Subject: Factory Direct Modification Campaign - Retrofit, Chain Slider Guard Mounting Bolts

Affected models: 2007 990 Adventure, 990 Adventure S and certain 950 Super Enduro

Picture 1

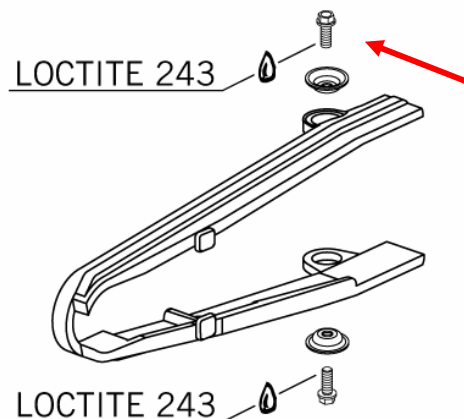
- » On affected models, during use the chain slider guard mounting bolts may become loose and possibly fall out; this could result in the possibility of the chain slider guard becoming detached. The chain slider guard could become caught in the drive chain and subsequently lead to an accident which could cause injury or death to the rider or others.

- » It has been determined that the cause of the defect involves an assembly error at the factory. During assembly the chain slider guard mounting bolts should have been installed with the use of Loctite 243 on the threads. If Loctite 243 was not used during the assembly process the bolts could loosen and fall out. To remedy this; it is required that the 2 bolts that attach the chain slider guard to the swingarm (see Pic 1) are secured with Loctite 243 and torque to 6Nm.

- » **Please note:** Check for the correct length of the chain slider guard mounting bolts on the 950 Super Enduro. The correct mounting bolts are 6mm x 1.0 x 16mm long. If the bolts are not the correct length, please order a replacement bolt from the dealer net fiche finder.

- » Please remove the 2 bolts that attach the chain slider guard to the swingarm (see Picture 1) and secure them with Loctite 243 and torque to 6Nm.
